Technical Note

From Steer

Project Downham Road Design Options Assessment

Downham Road Optioneering - Multi-Criteria Assessment

Option 1 - Kerb Buildouts with Chicane (A10 to De Beauvoir Road)

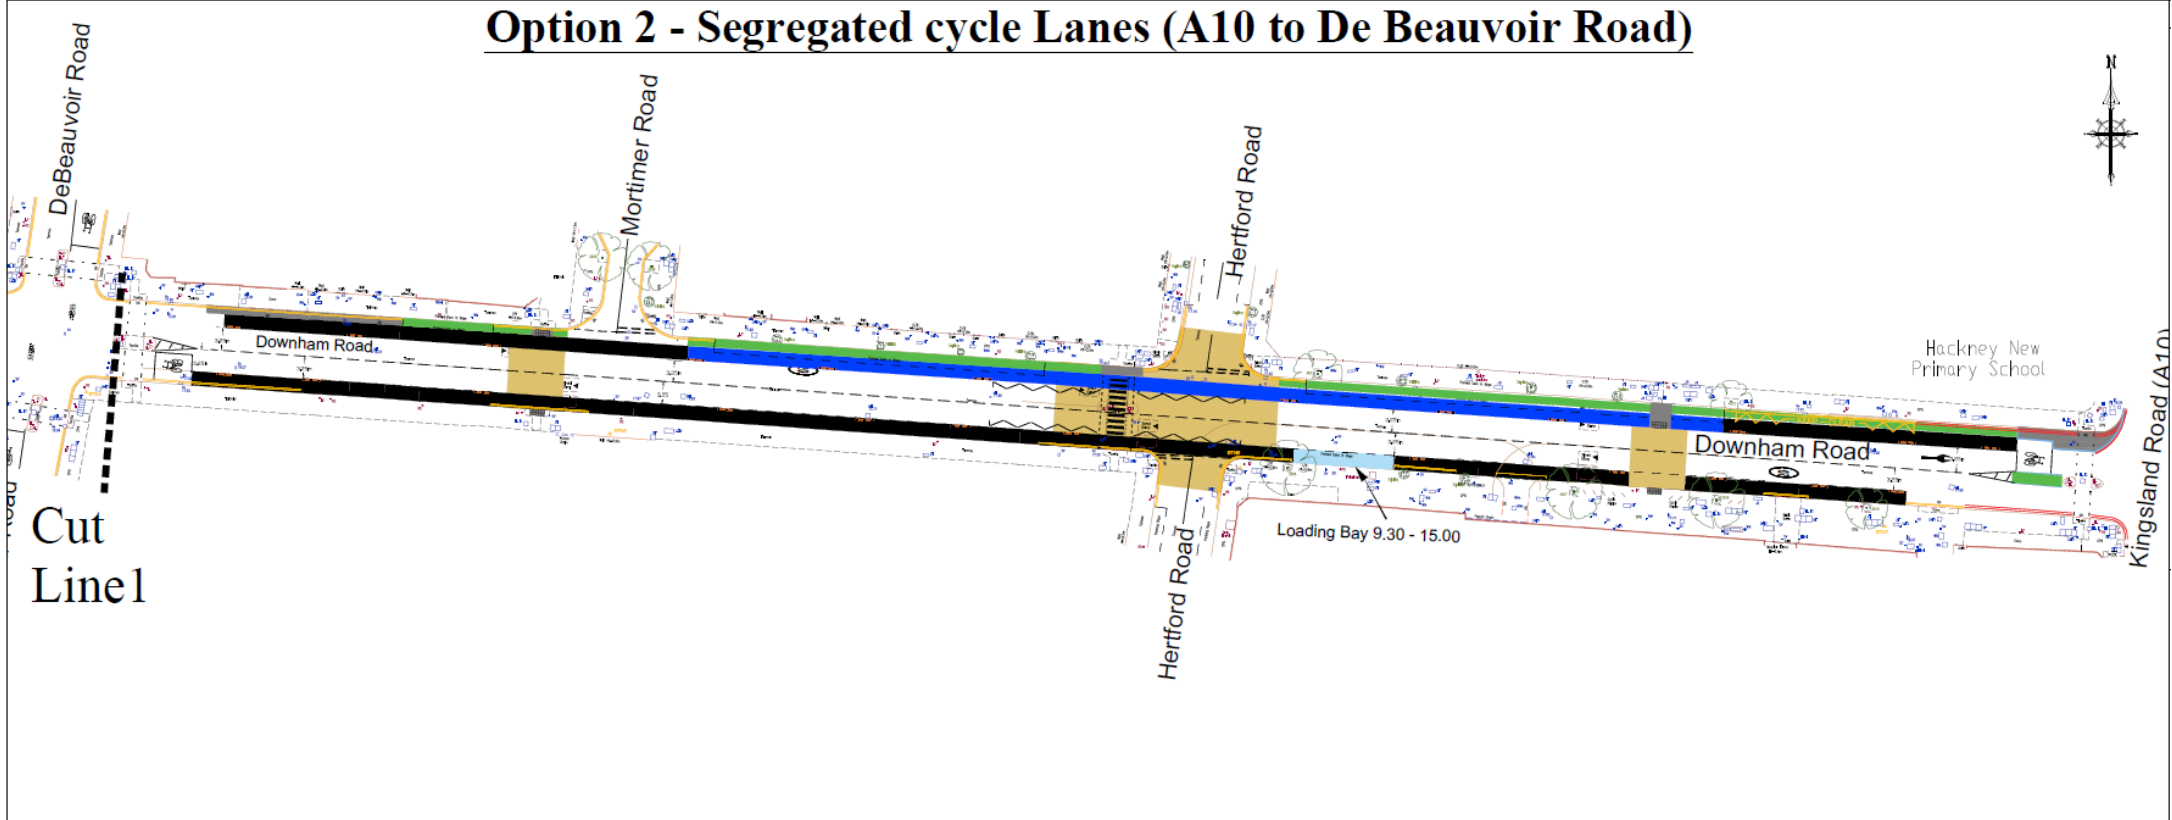
- All footway buildouts are shown as 'planting areas' apart from where there are pedestrian crossing points. Whilst this is likely to be adequate based on current footfall, a Pedestrian Comfort Level (PCL) assessment would be beneficial to establish whether this extra footway space is necessary, or whether it can be allocated to planting.

- It would be possible to further improve the walking and cycling environment with the introduction of continuous footways over minor side roads such as Hartford Road and Lawford Road. This would emphasise pedestrian and cyclist priority and assist with slowing down drivers on entry and exit. Except for Southgate Road and De Beauvoir Road, all side roads experience very low flows of motor traffic due to existing road network configuration.

- Consideration could be given to the layout of the proposed buildouts, using appropriate radii and extending the buildouts across vehicular accesses to prevent having frequent gaps in the buildouts.

- Consideration could be given to providing a zebra crossing at the raised table near Hackney New Primary School entrance, rather than west of Hertford Road. This however would need to be reviewed against traffic volumes to ensure that it does not cause issues with queueing at the junction with the A10.

- The two chicanes, west of Ufton Road and outside the school entrance are designed with a taper of 1:3-1:4, which is considered very sharp, and might lead to kerb overruns or conflicts between vans and other large vehicles travelling in opposing directions. Although there is a weight restriction on Downham Road, there are exceptions for loading, and larger vehicles would need to enter the opposing lane to manoeuvre through the chicanes which could lead to safety issues.

- It is recommended that the stagger length of the chicanes is increased to mitigate this, however this could reduce their effectiveness in reducing speeds. Raised tables will assist with this (to be designed with appropriate gradients to avoid grounding and excessive noise/vibration).

Option 2 - Segregated cycle Lanes (A10 to De Beauvoir Road)

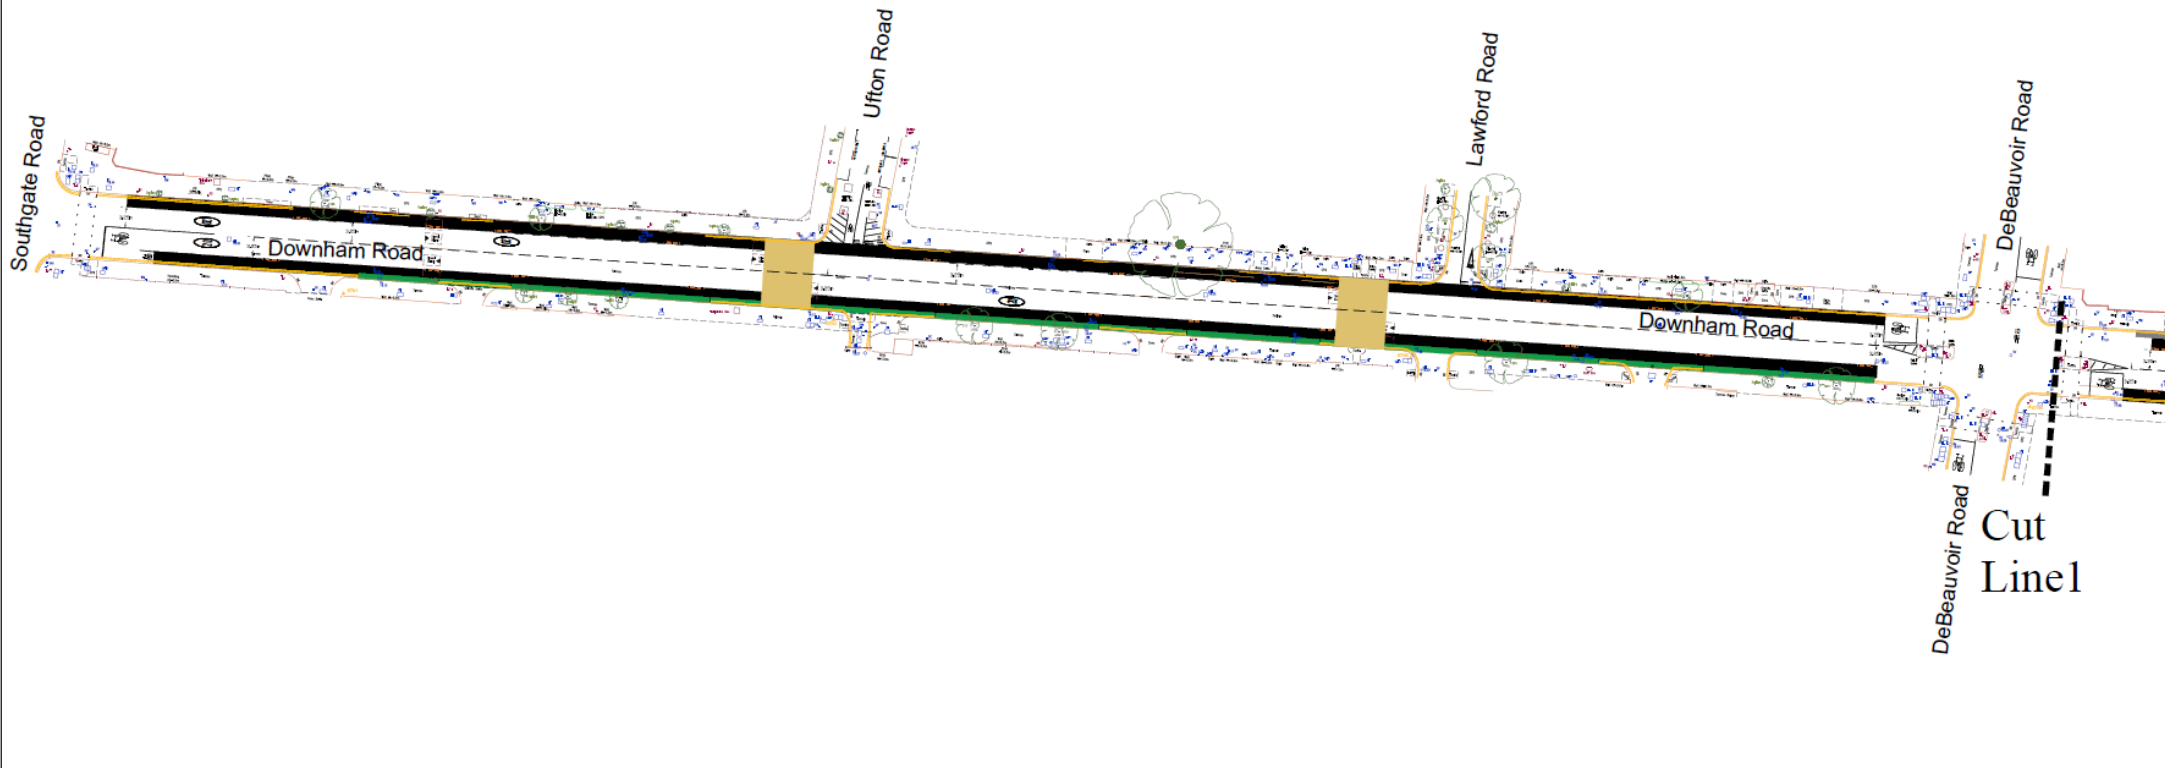
- it would be possible to further improve the walking and cycling environment with the introduction of continuous footways (and cycleways) over minor side roads such as Hartford Road and Lawford Road. This would emphasise pedestrian and cyclist priority and assist with slowing down drivers on entry and exit. Except for Southgate Road and De Beauvoir Road, all side roads experience very low flows of motor traffic due to existing area-wide filtering. An example of this is shown in **Figure 3** below, from Markhouse Road in Waltham Forest.

- Consideration could be given to providing a zebra crossing at the raised table near Hackney New Primary School entrance, rather than west of Hertford Road. This however would need to be reviewed against traffic volumes to ensure that it does not cause issues with queueing at the junction with the A10.
- Crossing the cycle lanes and two lanes of traffic in one movement, at the proposed uncontrolled pedestrian crossings points, can be challenging, especially given the relatively high flows of motor traffic on Downham Road. This applies particularly to children and elderly. Consideration could be given to introducing an additional zebra crossing on the section between De Beauvoir Road and Southgate Road.

- Parking stress data suggests that existing demand on Downham Road and adjacent side roads could be relatively low, considering only residents. However, it would be beneficial to undertake a parking beat survey across the area in advance of recommending that designs for both options are amended to reducing or relocating as much parking and loading bays as necessary onto side roads. This would have substantial benefits to the overall public acceptability of the scheme, though particularly for Option 2, which at present would require the removal of all car parking spaces.
- The proposed loading bay on the cycle track (east of Hertford Road, outside The Duke of York pub) poses a road safety risk for cyclists, even though operations are time restricted. Consideration should be given to relocating the bay into Hertford Road as an alternative.

Using chicanes vs narrowing the carriageway width

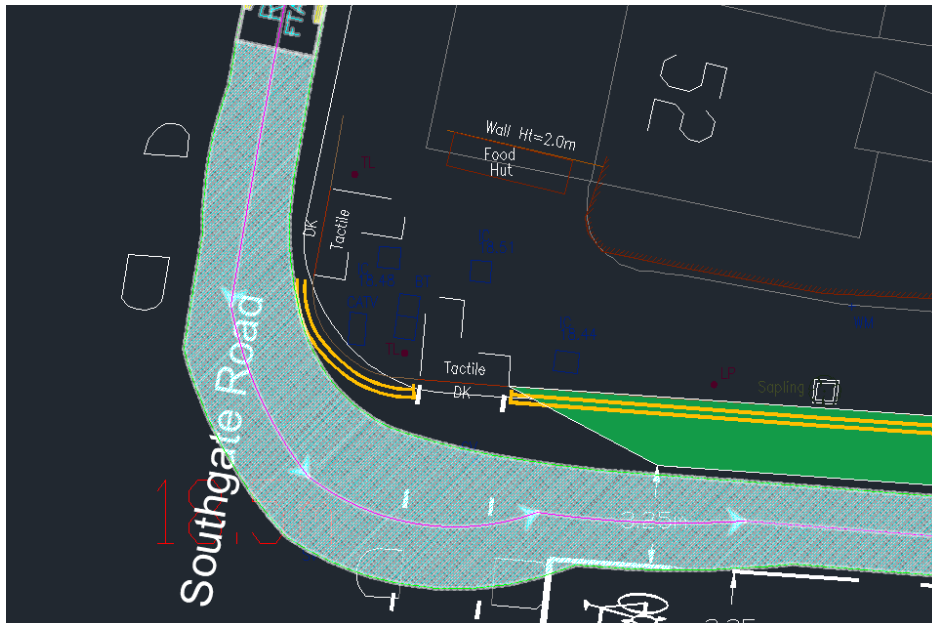
- An alternative to the chicanes would be to introduce carriageway narrowing's (6m or less), building out the footways on both sides. It is recommended that consultation is undertaken with emergency services to establish the most appropriate design solution.
- The carriageway width along Downham Road could be reduced further to 6m rather than 6.5m. 6.5m is generally considered the minimum carriageway width along bus routes, however two-way carriageways within 20mph zones/roads can be to 6m when not used by buses. This would be especially beneficial for cyclists, allowing them to choose to ride in primary position (or at footway pinch points highlighted in the MCA where this extra width could be used to widen the footways).

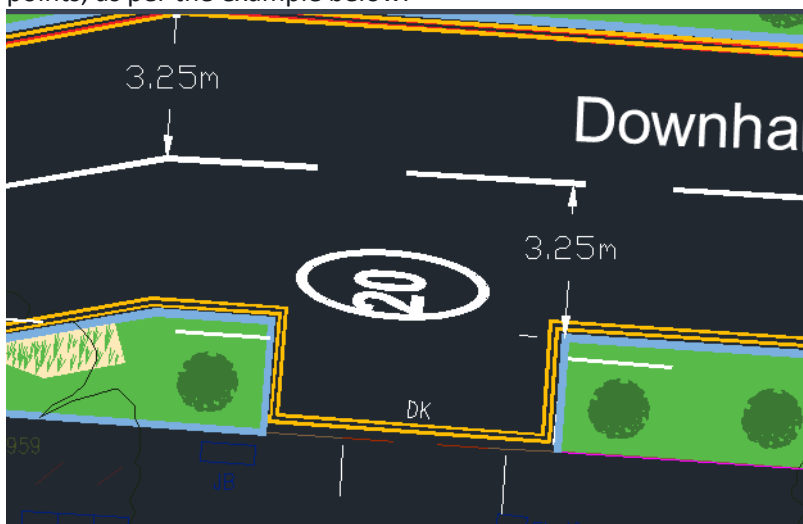
- **Junction with Kingsland Road:** Retaining only one approach lane would require an assessment of the capacity of the junction. Consideration could also be given to removing the traffic island and reallocating this space to the footways – subject to vehicle tracking.
- **Junction with De Beauvoir Road:** It is recommended that cycle feeder lanes to the ASLs are provided where space is available. Consideration should be given to removing traffic islands and building out footway corners instead to reduce crossing distances, or alternatively reallocating the space for cycle feeder lanes. There is no need for traffic islands to mount signals if there is only one approach lane.
- During detailed design, ensure that proposed trees do not obstruct visibility or accesses or at crossing points, as per the example below:
